October 29, 2014
RC-14-0173

Subject: VIRGIL C. SUMMER NUCLEAR STATION (VCSNS) UNIT 1
DOCKET NO. 50-395
OPERATING LICENSE NO. NPF-12
SOUTH CAROLINA ELECTRIC & GAS COMPANY'S RESPONSE TO
REQUEST FOR ADDITIONAL INFORMATION – OVERALL INTEGRATED PLAN
IN REPOSE TO COMMISSION ORDER MODIFYING LICENSE
REQUIREMENTS FOR RELIABLE SPENT FUEL POOL INSTRUMENTATION
(Order No. EA-12-051)

**Virgil C. Summer Nuclear Station Unit 1 - Response to Request for Additional Information
- Overall Integrated Plan in Response to Commission Order Modifying License
Requirements for Reliable Spent Fuel Pool Instrumentation (Order No. EA-12-051)**

Figure 1 Vega Waveguide Isometric (Northwest) Backup Channel

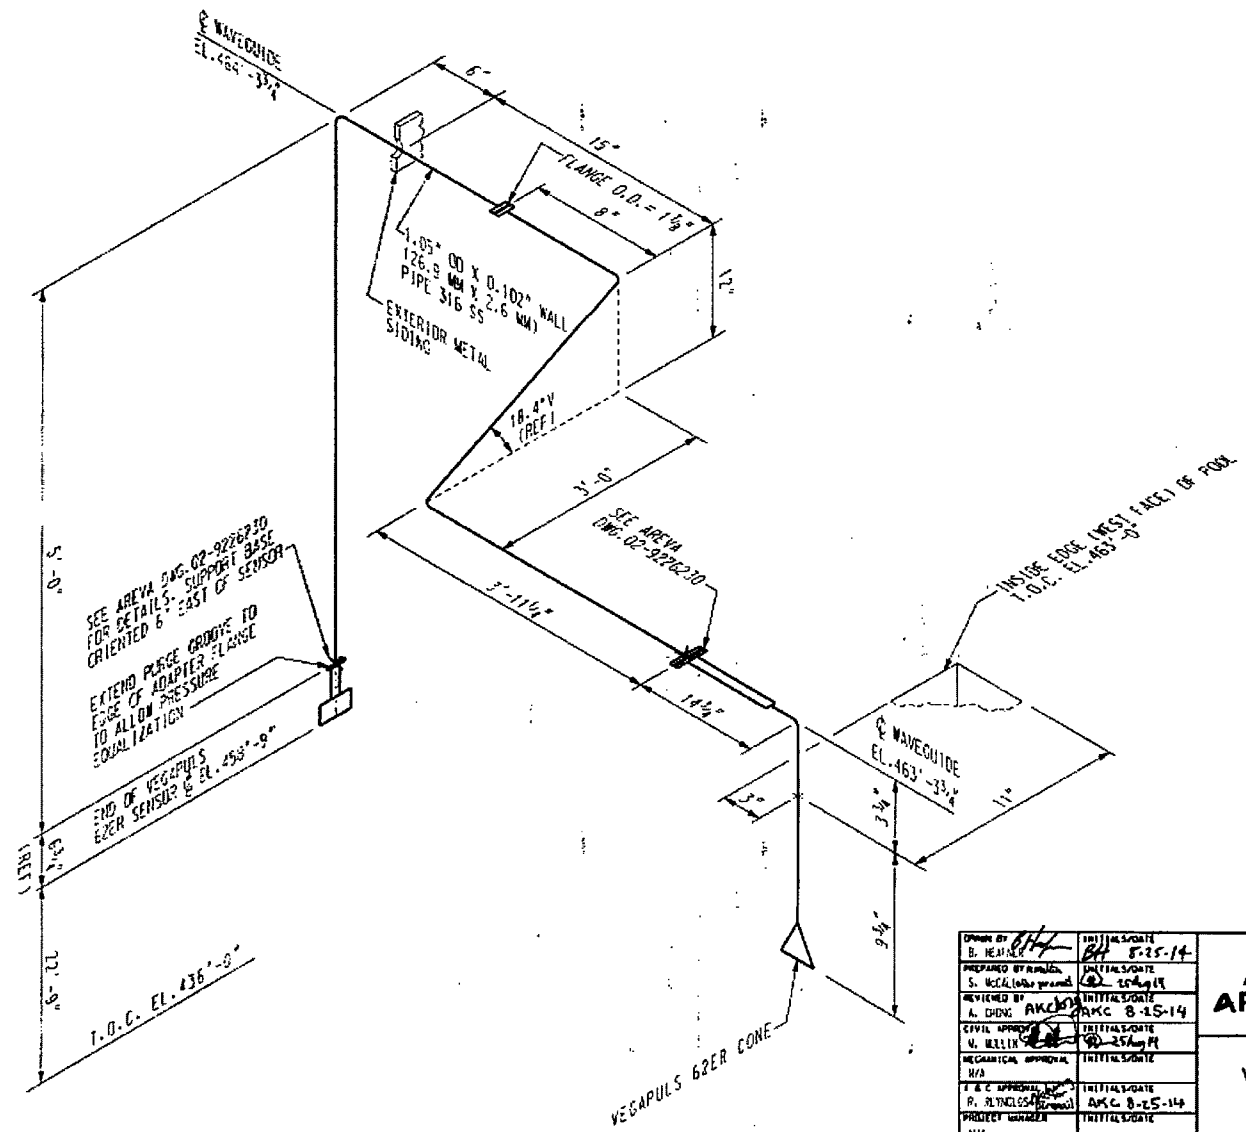
- a) The design criteria to be used to estimate the total loading on the mounting device(s), including static weight loads and dynamic loads. Describe the methodology to be used to estimate the total loading, inclusive of design basis maximum seismic loads and the hydrodynamic loads that could result from pool sloshing or other effects that could accompany such seismic forces.**

- b) A description of the manner in which the level sensor (and stilling well, if appropriate) will be attached to the refueling floor and/or other support structures for each planned point of attachment of the sensing/waveguide assembly. Indicate in a schematic the portions of the level sensor/waveguide that will serve as points of attachment for mechanical/mounting or electrical connections.**

- c) A description of the manner by which the mechanical connections will attach the level instrument to permanent SFP wall or floor structures so as to support the waveguide/level sensor assembly.**

The horn mounting support will be qualified similarly to the remote transmitter support. It will be qualified by a site-specific calculation using a simple C-channel steel section with base plate on the concrete operating deck floor in the spent fuel pool area. The generic design of the horn mounting support conservatively uses generic seismic accelerations of 10g (horizontal) and 6.67g (vertical). A visual representation of the pool edge mounting configuration for the radar horn is shown in the attached, Figure 1 and Figure 2. It also provides the mounting configuration.

- b) & c) The waveguide piping assembly, horn, and remote transmitter are designed to attach to the spent fuel pool concrete floor, outside west wall of the Fuel Handling Building, and east wall of the north Auxiliary Building stairwell by means of mounting supports. These mounting supports consist of sensor support and horn support. Spacing of the mounting supports complies with site specific specifications and standards and qualification restrictions for the waveguide pipe assembly. Figures 1 and 2 show the designed attachment points for the waveguide piping and horn assembly.

Figure 2 Vega Waveguide Isometric (Southwest) Primary Channel

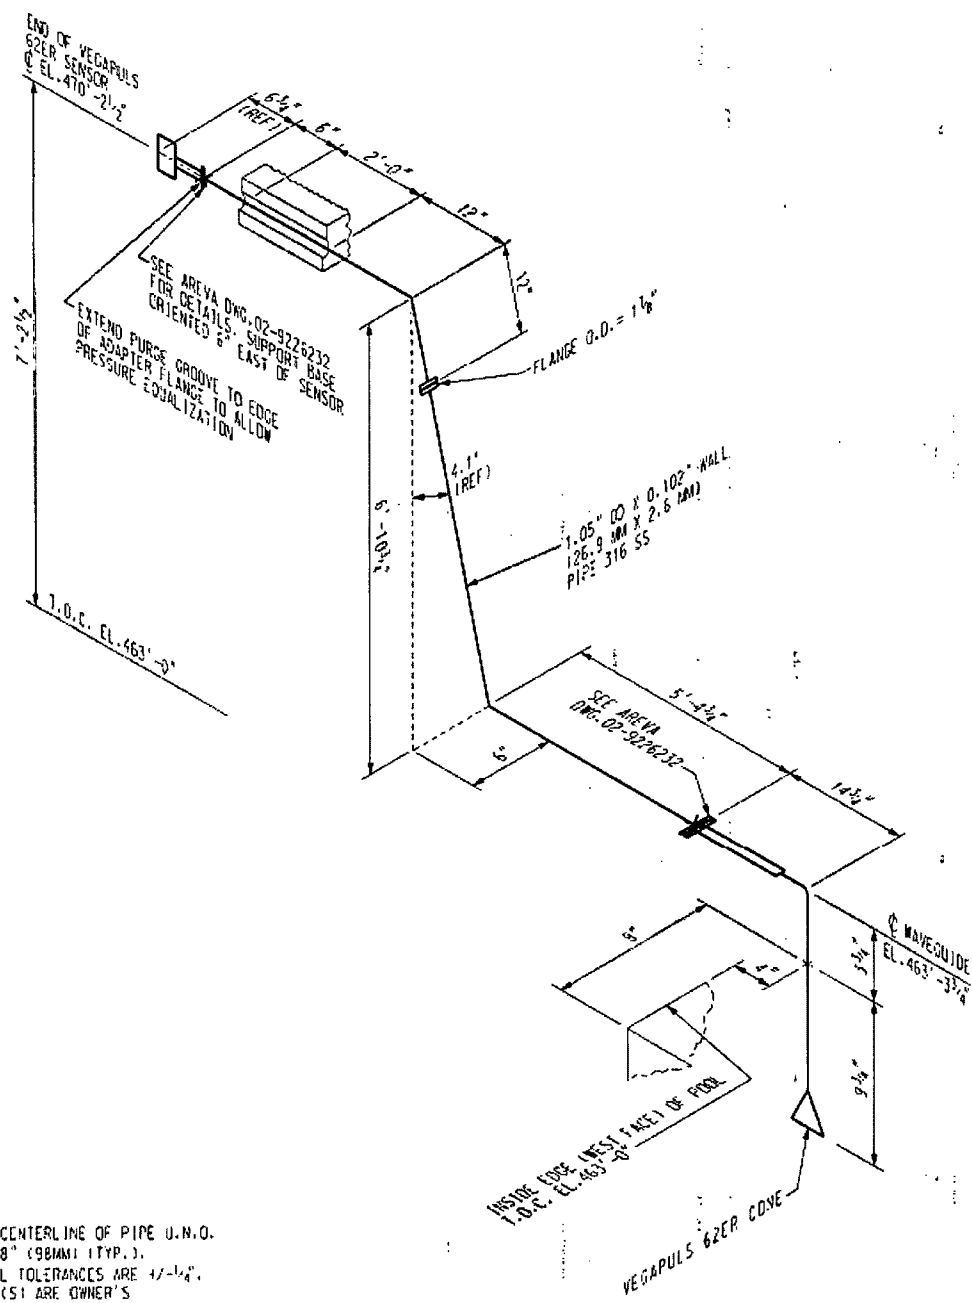
Please provide an evaluation verifying the seismic testing of the horn and waveguide assembly and the electronics units, and the analysis of the combined maximum seismic and hydrodynamic forces on the cantilevered portion of the assembly exposed to the potential sloshing effects, demonstrate that the SFP instrument design configuration will be maintained during and following the maximum seismic ground motion considered in the design of the SFP structure.

The horn mounting support will be qualified similarly to the remote transmitter support. It will be qualified by a site specific calculation using a simple C-channel steel section welded on a base plate on the concrete operating deck floor in the spent fuel pool area. The generic design of the horn mounting support conservatively uses generic seismic accelerations of 10g (horizontal) and 6.67g (vertical). A visual representation of the pool edge mounting configuration for the radar horn is shown in Figure 1 and Figure 2. It also provides the mounting configuration.
